Important Safety Recall

Recall Number: NHTSA 22V933/Transport Canada 2022-217

Product Line: 2022-2023 Interstate 24X

Subject: Galley Roof Locker Securement

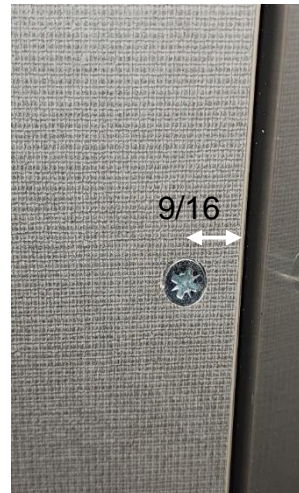
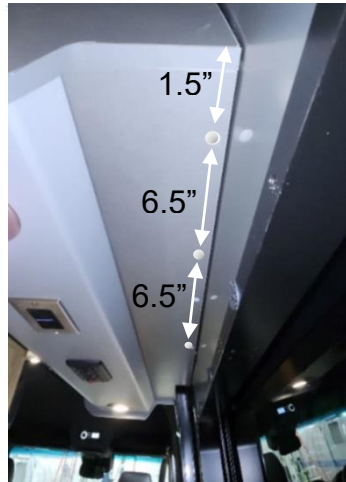
Airstream has determined that the overhead galley cabinet can come loose from the interior wall on certain 2022-2023 Interstate 24X motorhomes. The fasteners holding the overhead galley cabinet in place may fail in transit which would allow the overhead galley cabinet to separate from the interior wall of the vehicle. If the galley cabinet separates from the wall and would fall while the motorhome is in transit, there is increased risk of a crash, personal injury and/or property damage.

Once identified, you will need to add 3 screws to the bottom of the locker. The 3 screws will attach into a wooden support, on the inside of the locker.

The screws will go into the underside of the overhead microwave cabinet. Below, is a photo showing the screws already installed.

1. Measure the location for each screw.
 - a. From the bottom of the locker measure the first location 1.5" from the rear and then 6.5" for the next two. From the side wall, each screw will be centered at 9/16" in.

2. Using a #30 or 1/8" drill bit, drill a pilot hole for each screw. Be careful not to drill deeper than 1".
3. Next, use a countersink bit to the bevel hole. This will relieve the pressure on the Formica.
4. Finally, install the 3 screws and use the caps to cover the screw heads.
